PROJECT ID NO. SWQ0000005

**MONTEITH PARK AND VIEW PARK
GREEN ALLEY STORMWATER IMPROVEMENTS**

NOTICE INVITING BIDS

CAPITAL PROJECT NO. CP-69813 | LACFPD INDEX NO. 275-679-D4.3 | SHEET 3 OF 23

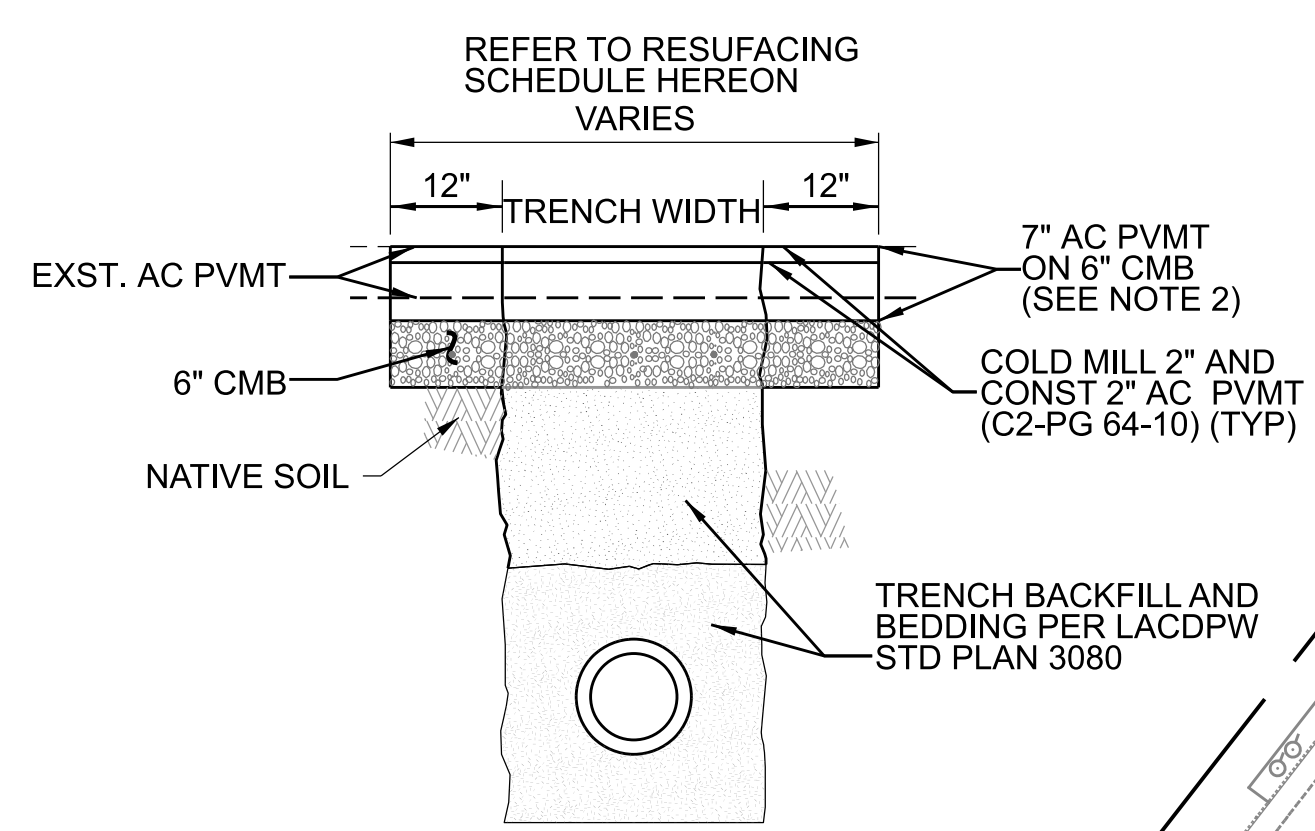
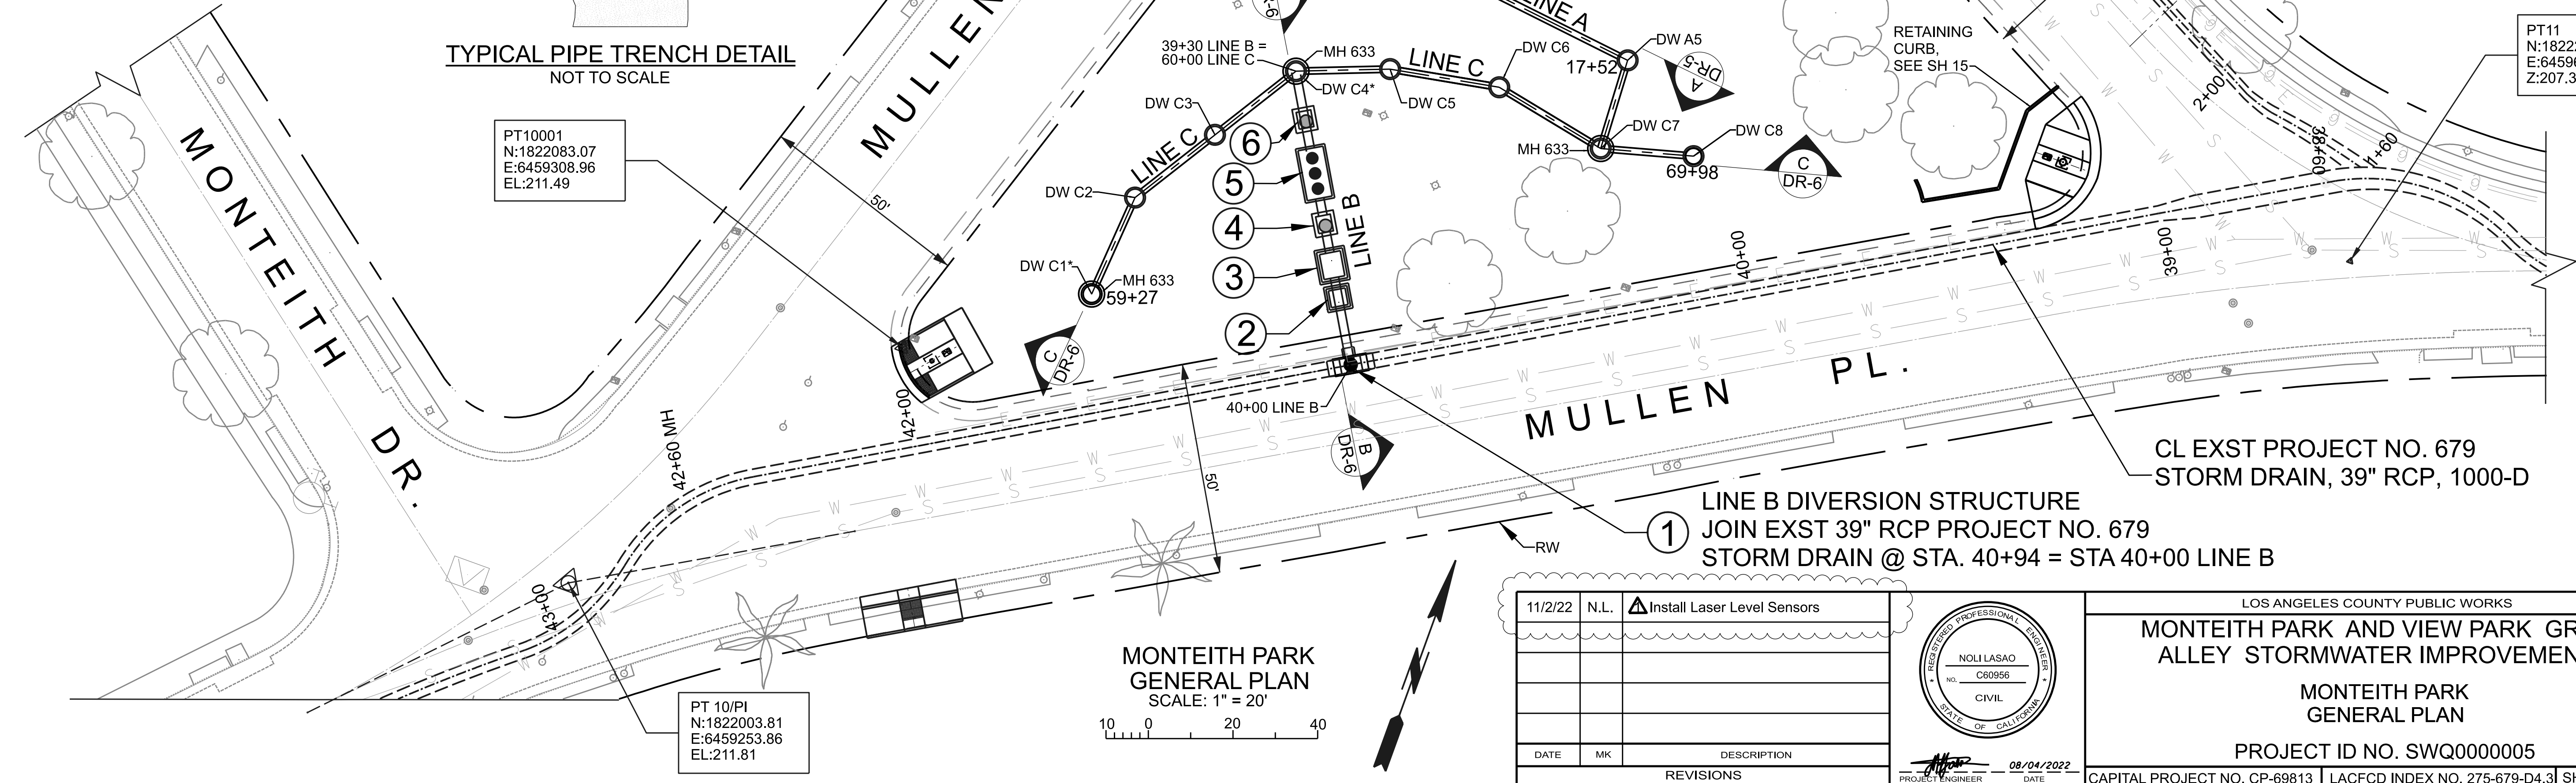
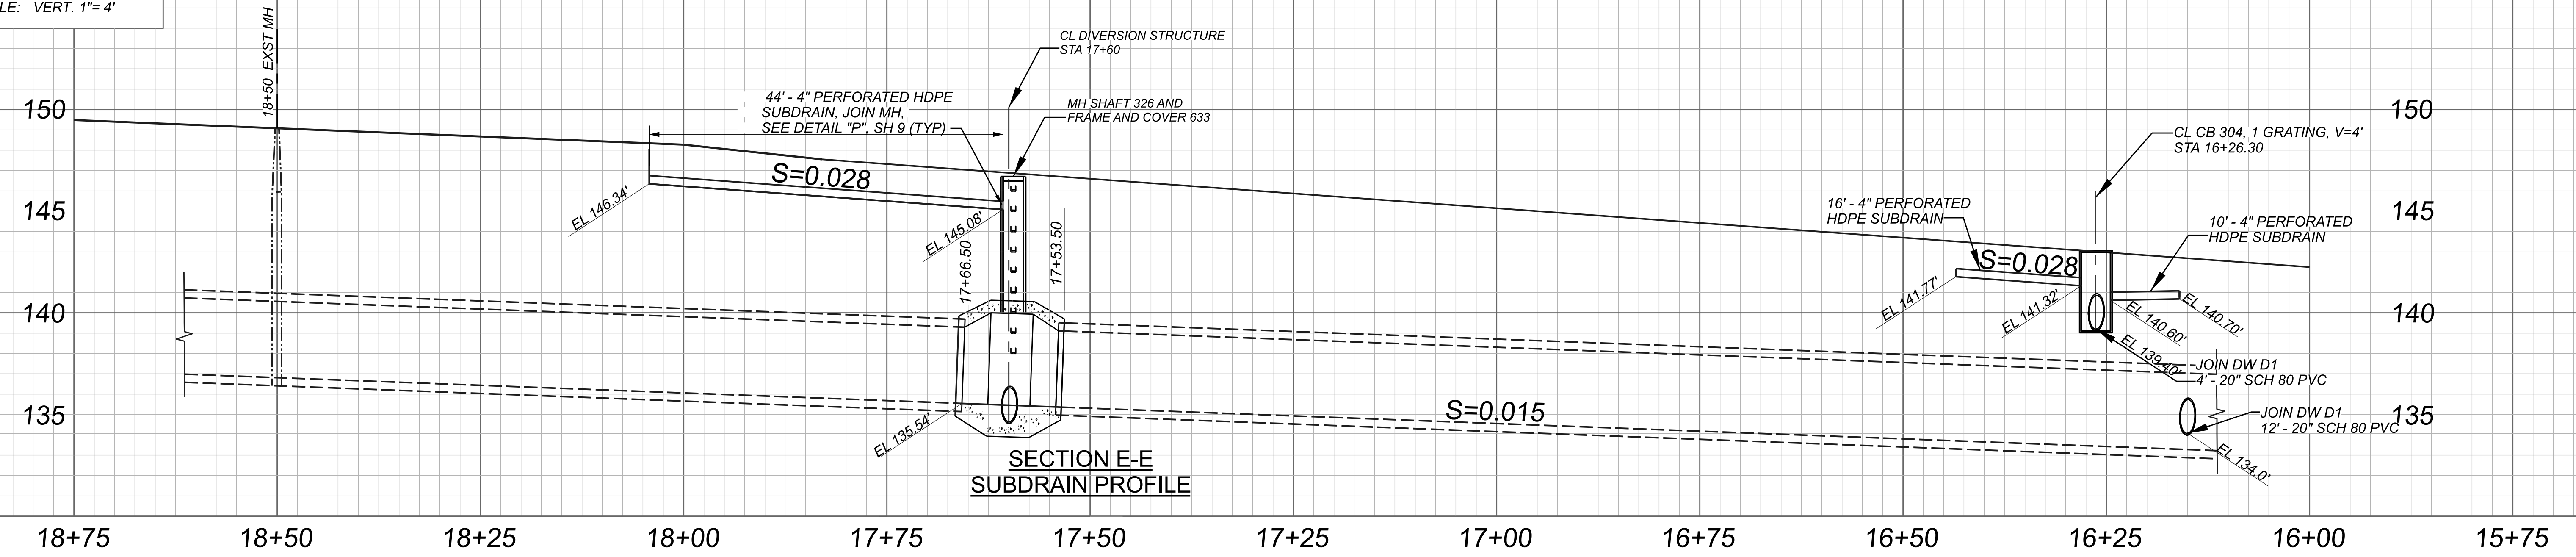
DATE	MK	DESCRIPTION
11/2/22	N.L.	Install Laser Level Sensors

- Sheet DR-3 – Revised drywell note.
- Sheet DR-4 – Revised drywell note and callouts for D1, D3 and D4.
